Addendum No. 2
August 24, 2022

Project: **St. Mary Catholic School Addition & Remodel**
812 N. State Avenue
Dell Rapids, South Dakota 57022
Architecture Incorporated Project #2788

Scope of this Addendum:

SECOND FLOOR PLAN - AREA A - ALT. #5 - PLUMBING & HEATING
 SCALE 0 4 8 12 16

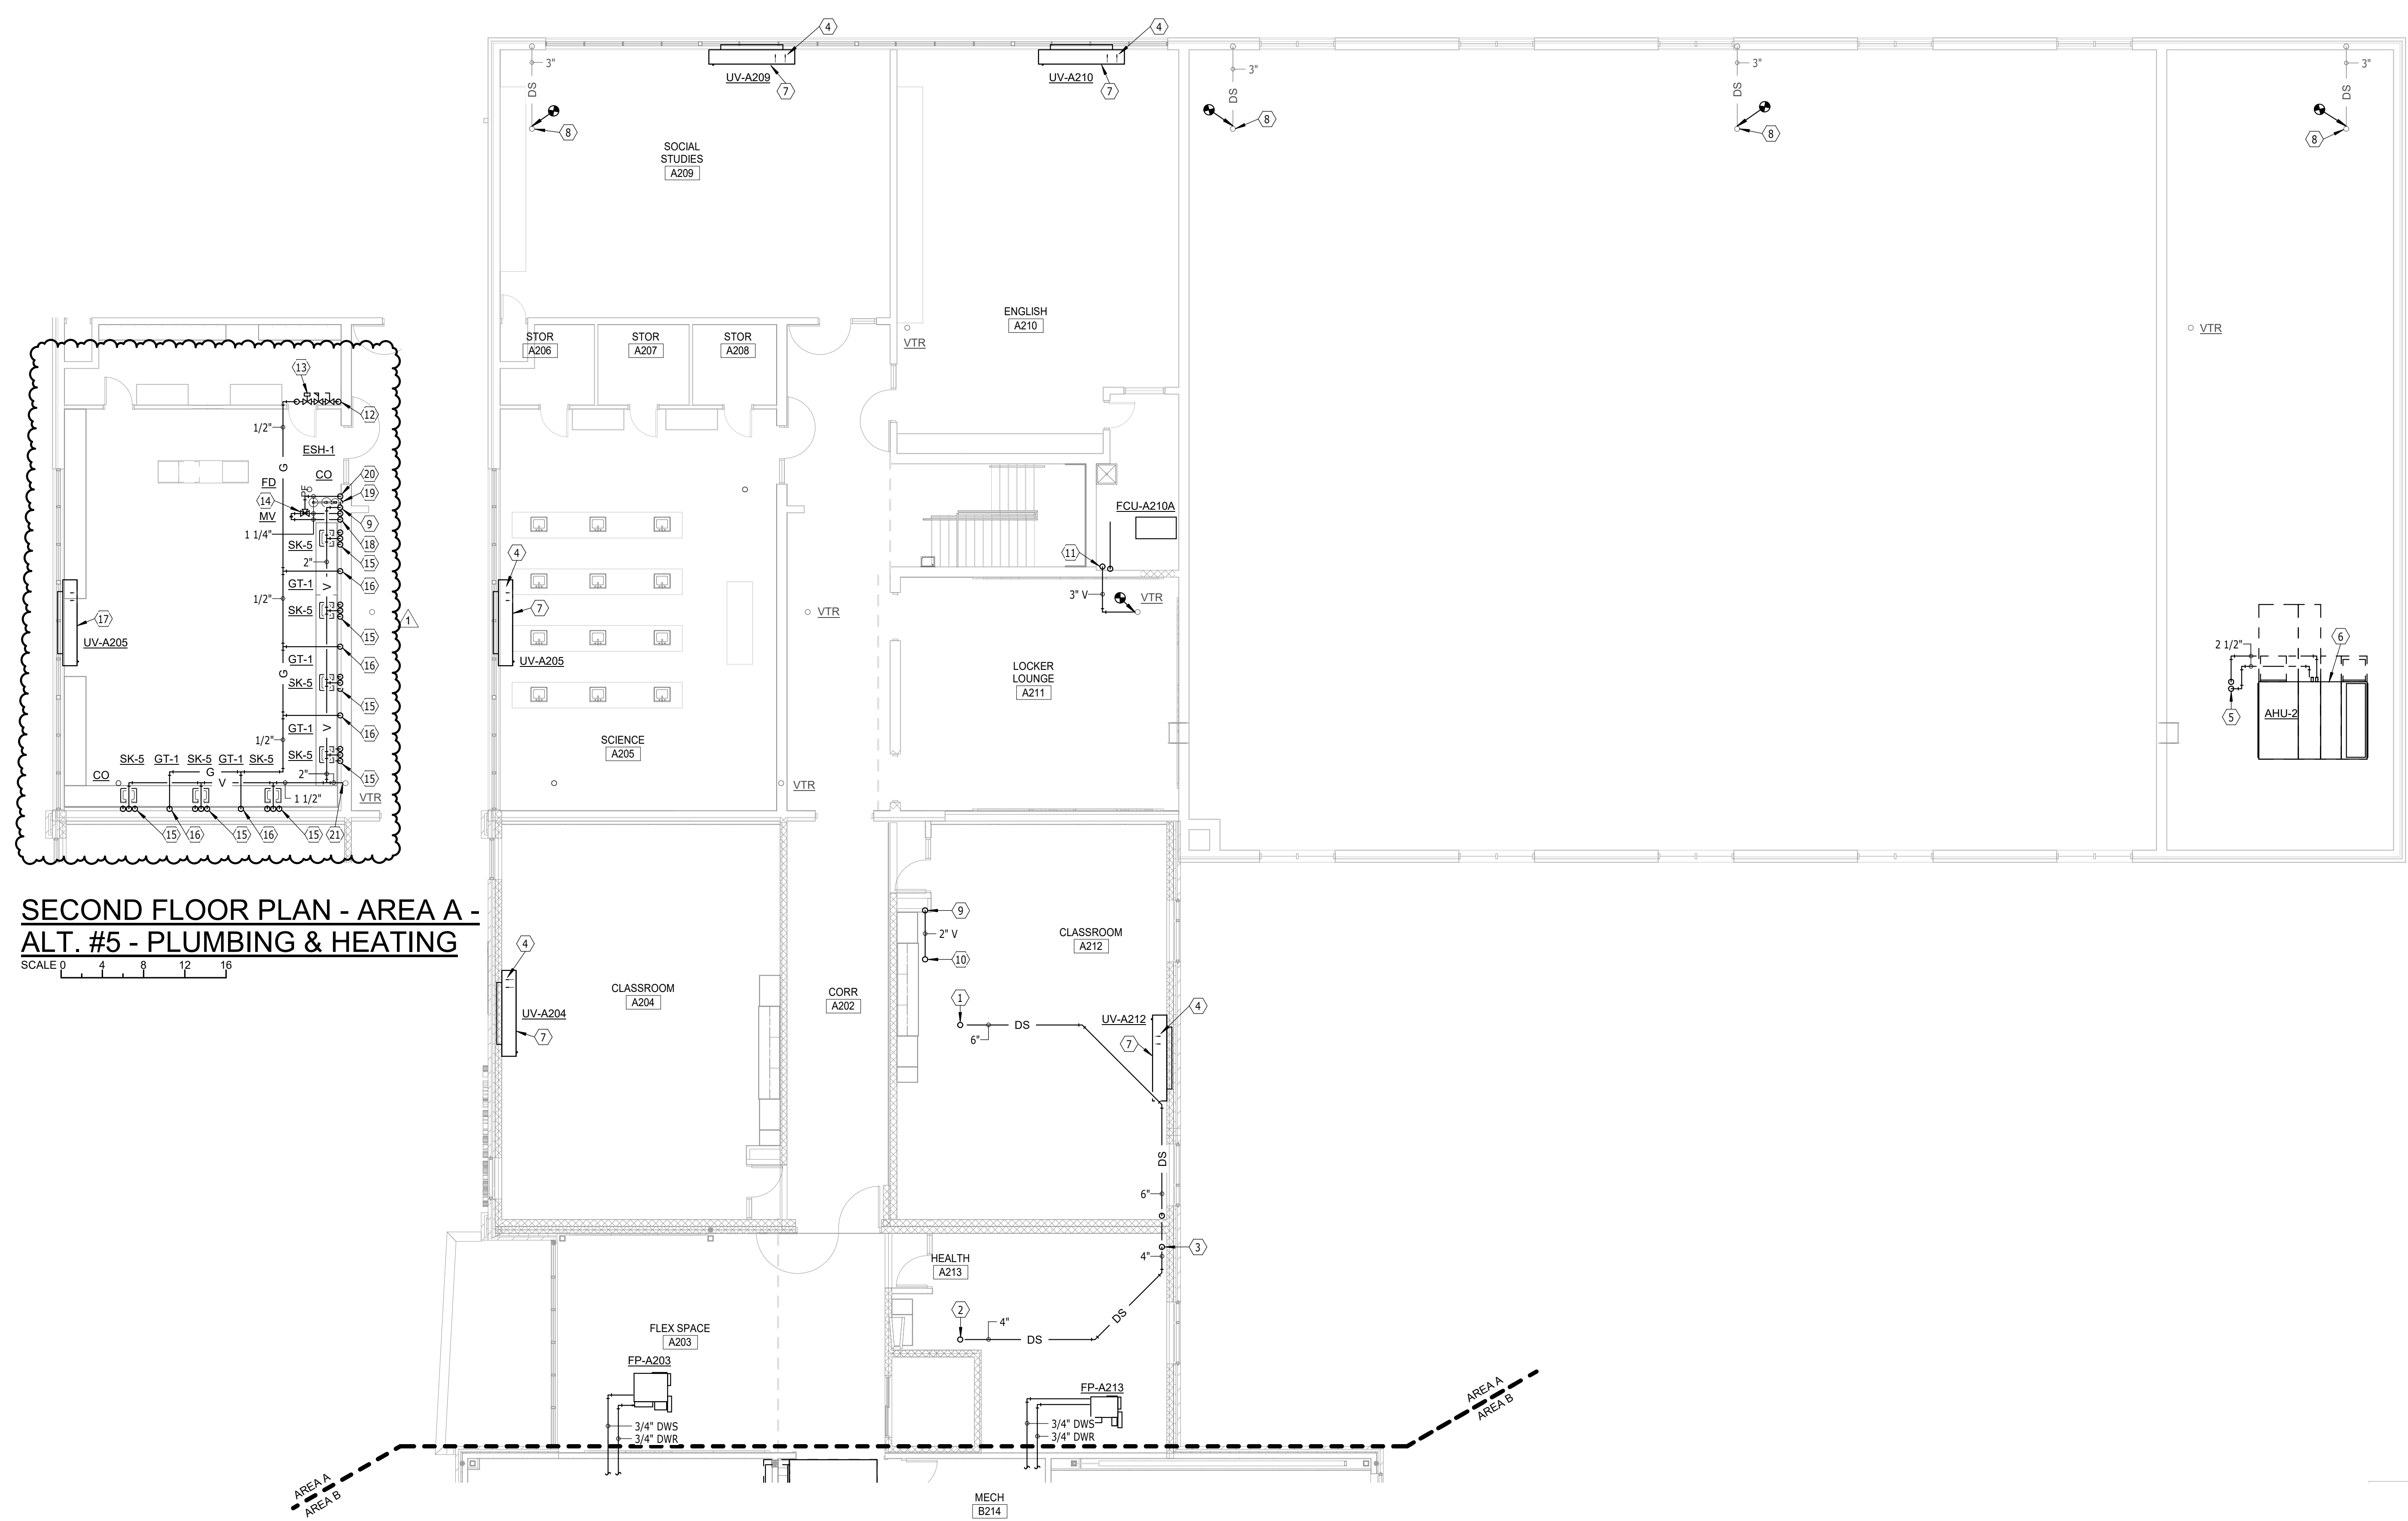
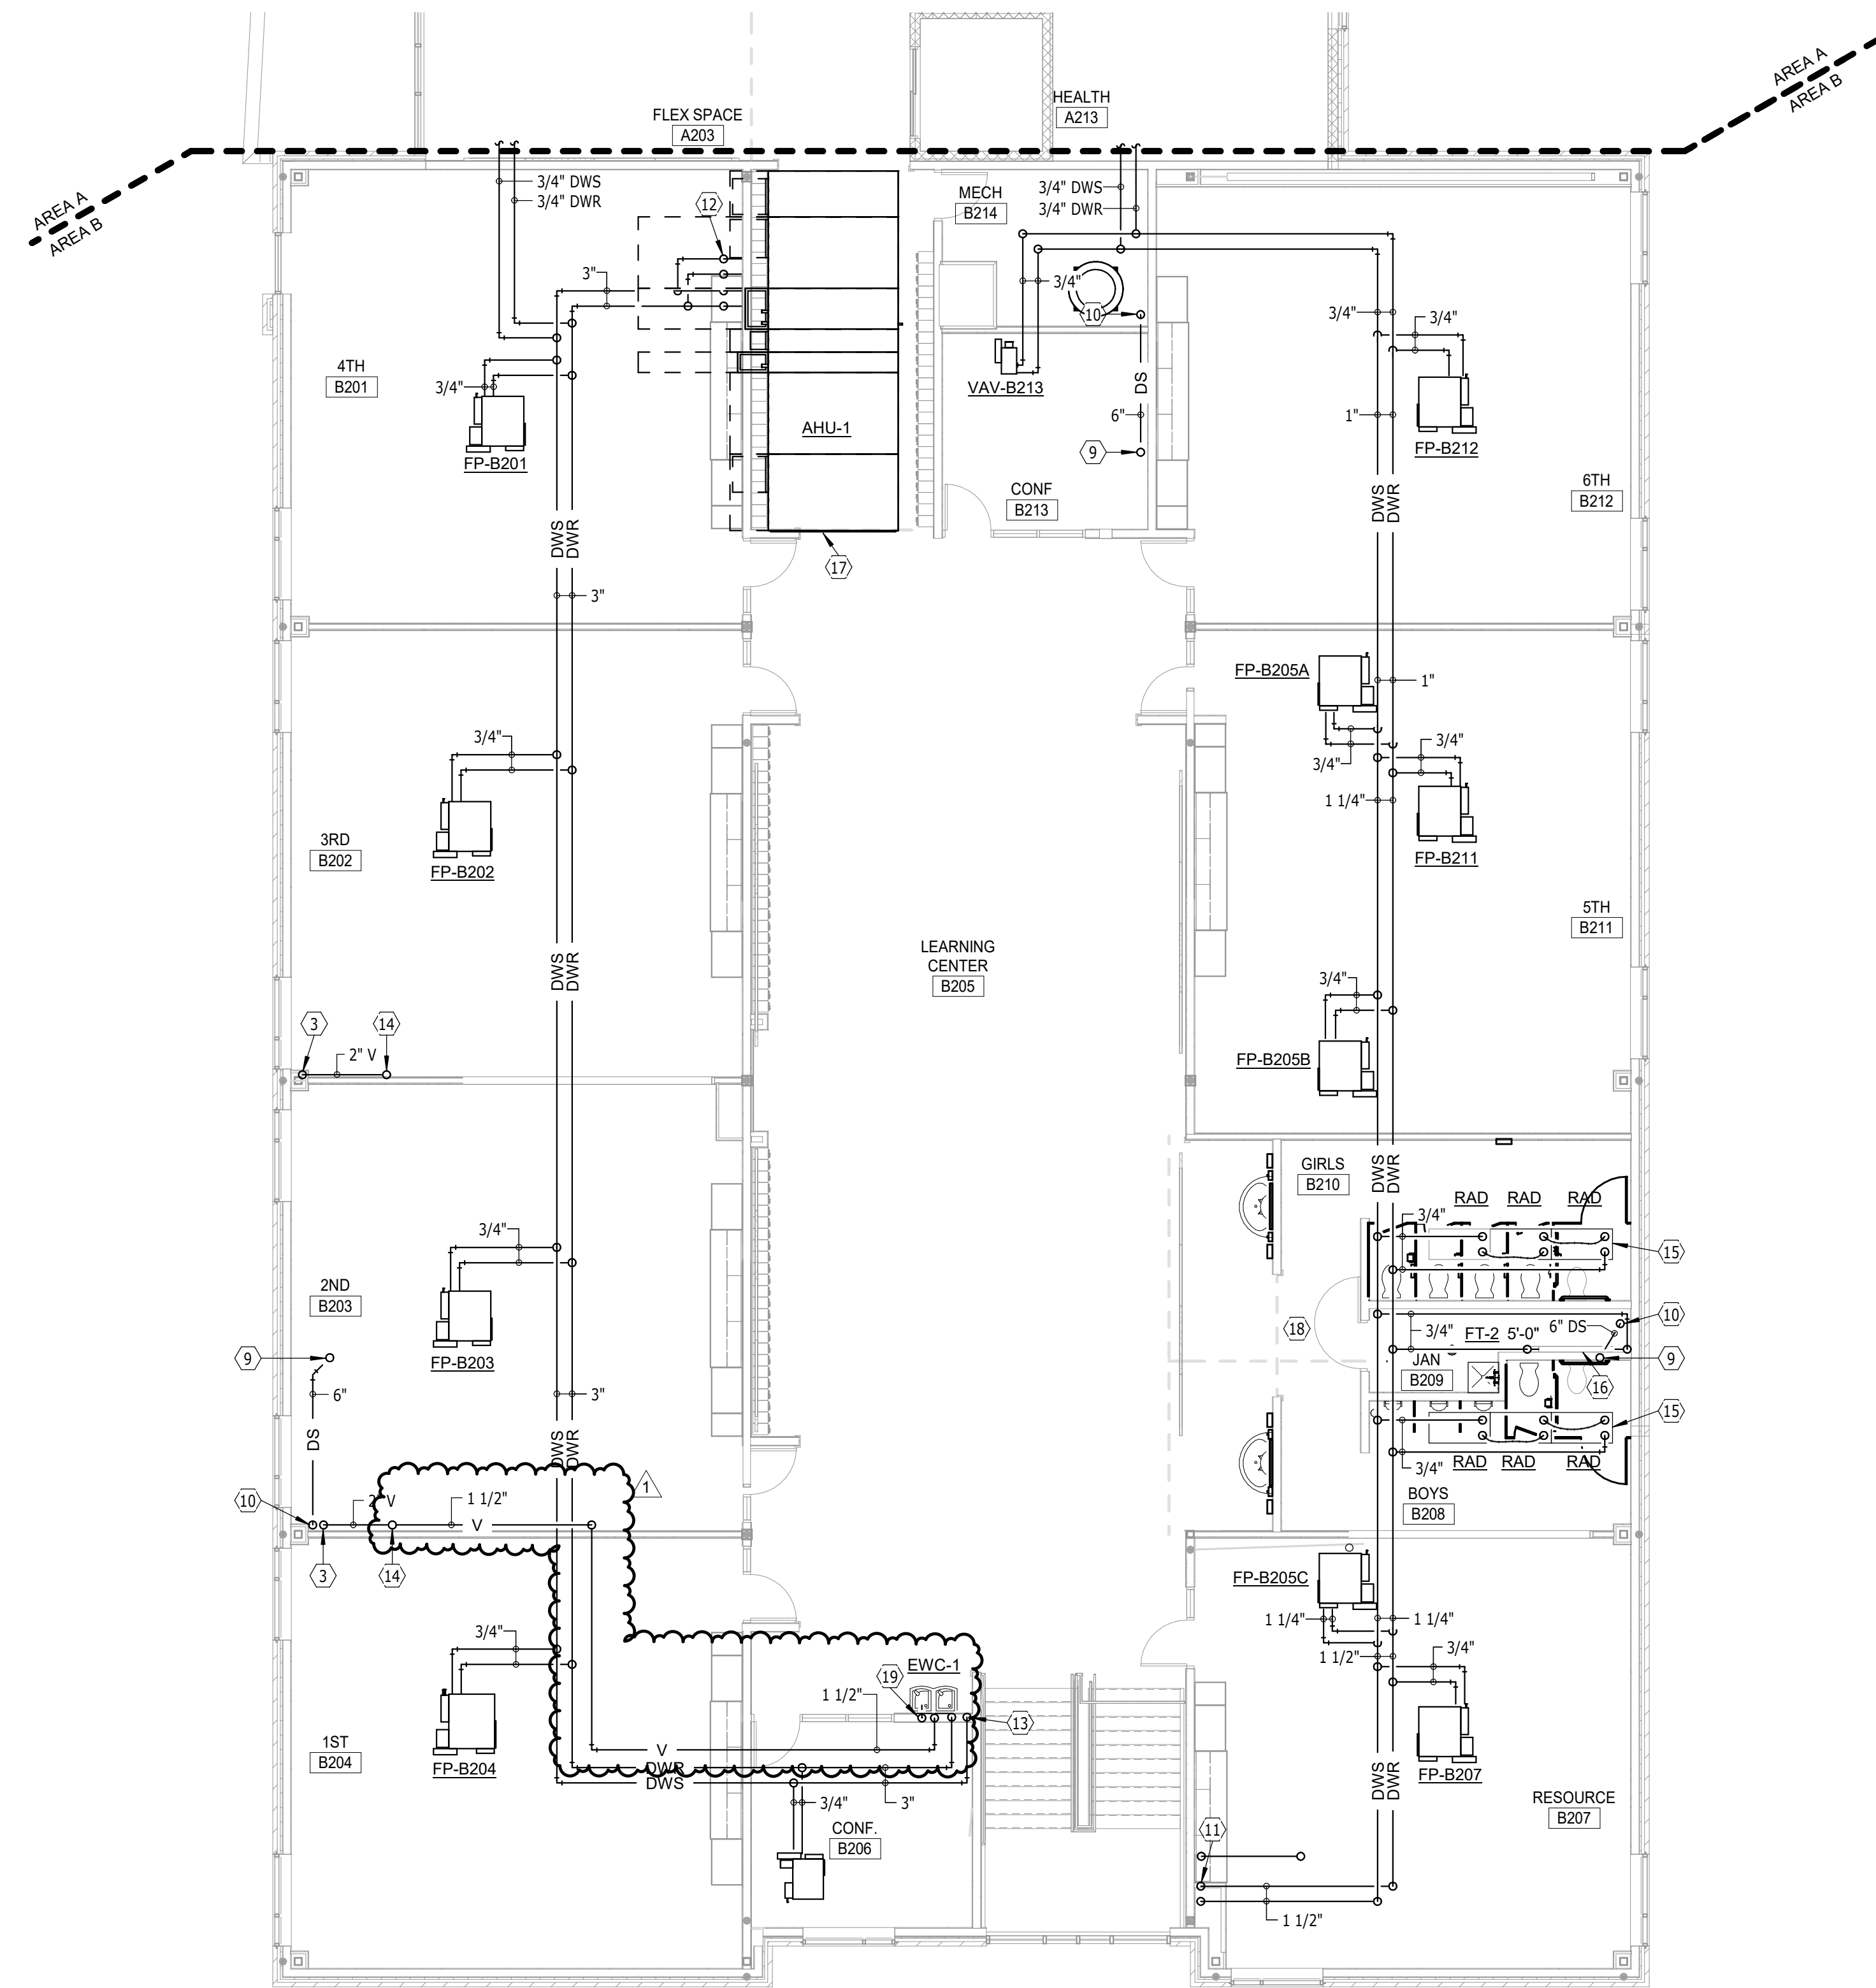
- a. Add plumbing fixtures and associated piping under Add Alternate #5. See attached sheet.
31. DRAWING SHEET 8.36 – SECOND FLOOR PLAN – AREA B – PLUMBING & HEATING
